Access Compliance Report

Public Rights-of-Way

Intersection ID: 10030374	Main Street: LEVINE AVENUE OF THE ARTS	Cross Street: N/A	Location: E
ADA ID: FE274BB787A2	Ramp Type: Perp	Initial Pass/Fail: Fail	Overall Compliance: No
Severity Score: 12.5			
Codes/Mitigation Info/Possible Solution		Field Measurements/Component Compliance

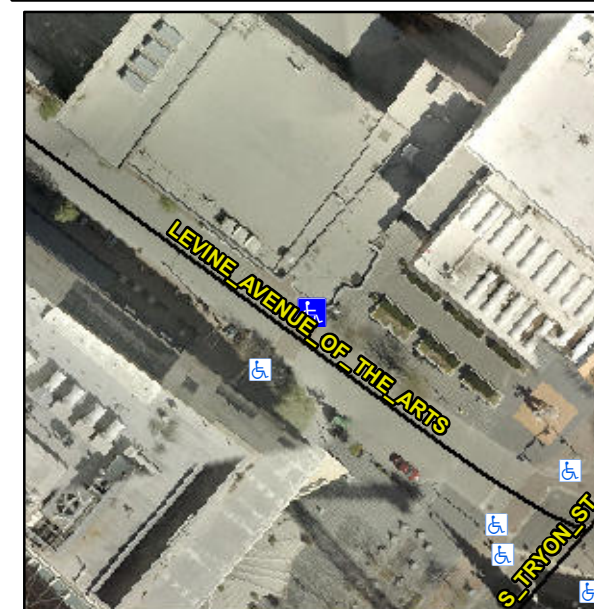
Compliance	Description	Data	Compliance	Description	Data
N/A	Ramp Length (in)	71.0	No	Ramp Slope (%)	10.0
Yes	Ramp Width (in)	59.0	Yes	Ramp XSlope (%)	1.7
N/A	Flare Type LT	N/A	N/A	Flare Type RT	N/A
N/A	Flare Slope LT (%)	N/A	N/A	Flare Slope RT (%)	N/A
N/A	Flare Traversable LT?	N/A	N/A	Flare Traversable RT?	N/A
N/A	Landing Length (in)	N/A	N/A	DWS Provided?	N/A
N/A	Landing Width (in)	N/A	N/A	DWS Contrast?	N/A
N/A	Landing Slope (%)	N/A	N/A	DWS Length (in)	N/A
N/A	Landing X Slope (%)	N/A	N/A	DWS Full Width?	N/A
N/A	Landing Curb? (Y/N)	N/A	N/A	DWS Offset (in)	N/A
N/A	Shared Landing?	N/A			
N/A	Gutter Ponding?	N/A	N/A	Gutter Slope (%)	N/A
N/A	Gutter Lip Ht (in)	N/A	N/A	Gutter X Slope (%)	N/A
N/A	Painted X Walk1?	Yes	N/A	Painted X Walk2?	N/A
	X Walk 1 Direction	To SW		X Walk 2 Direction	N/A
N/A	X Walk 1 Width (in)	150.0	N/A	X Walk 2 Width (in)	N/A
	X Walk 1 Slope (%)	2.3		X Walk 2 Slope (%)	N/A
	X Walk 1 X Slope (%)	1.1		X Walk 2 X Slope (%)	N/A

Remove & Replace Entire Ramp.
